Please find the 2024 May DRMS inspection report for Trapper Miine. This was an aerial inspection

28 May 2024

Permit Number: C1981010
Mine Name: Trapper Mine
Operator: Trapper Mining, Inc.
Operator Address:
Operator Address:
Operator Representative Present:
P.O. Box 187
Craig, CO 81626

Photo 4: A blast set up in L Pit, looking north.

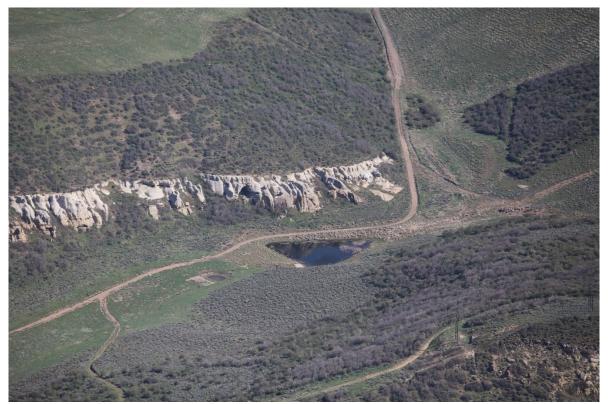
- o A blast appeared to be set up between J Pits East and West and in L Pit. (photos 4 and 13).
- o Blasting explosive permit has been extended and documentation placed in records.
